Appendix 14: Consultation

Robin Ashley Architects LLP

Enquiry Address: 118a Oxford Road & 2 Bedford Road, Reading

Reading Design Review Panel Comments

Figure 8 - three dimensional views of the proposals from the east and west.

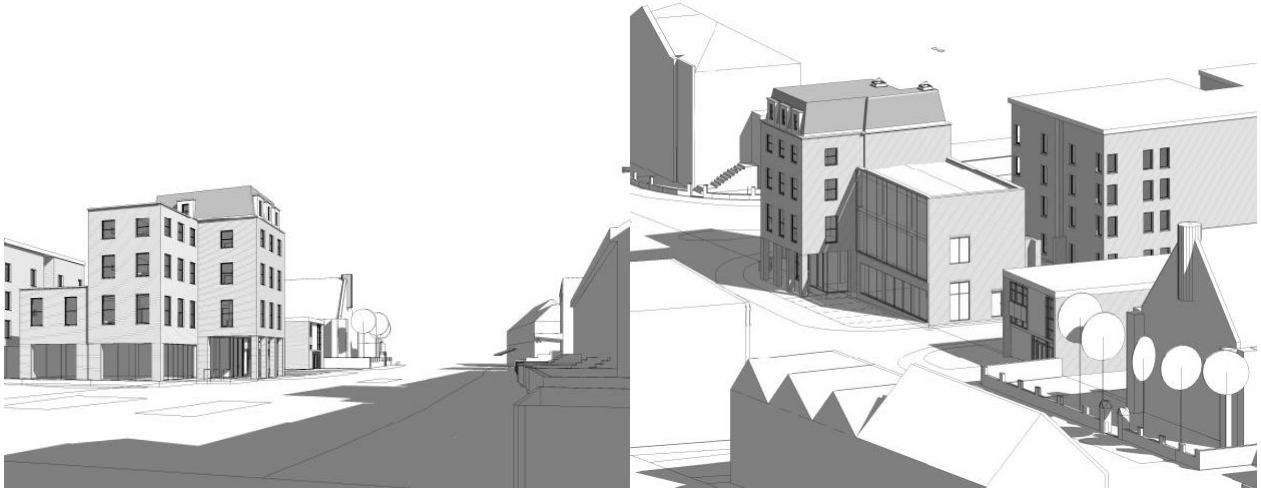
The meeting discussed the development of the scheme, and was generally supportive of the reduction in content and development of the design. There was lack of agreement regarding the southerly volume extending into the forecourt space, which was not supported. It was agreed to discuss the principles of the plan arrangement, which depend on entrance and vertical circulation on the east side, in greater depth with the conservation officer at a later date.
